TECHNICAL BULLETIN

[Issue No.] FA-A-0095

[Title] Changes in the appearance of the AJ65BT-D75P2-S3 positioning module

[Relevant Models] AJ65BT-D75P2-S3

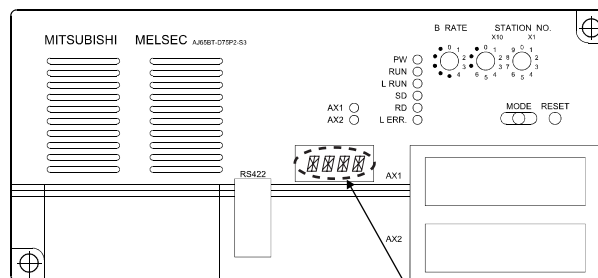
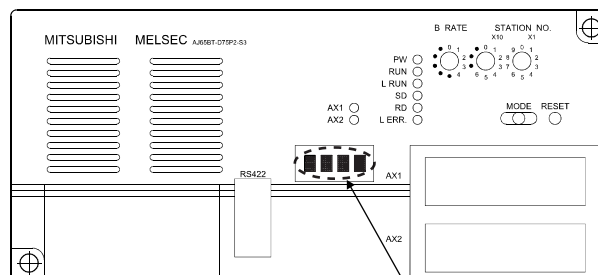
The 17-segment LED display has been changed to the LED module.

Note that the display method, general and performance specifications, and all other features of these models are unchanged.

Before change

17-segment LED

After change

LED module

The changes are applied to the AJ65BT-D75P2-S3 hardware version L or later.
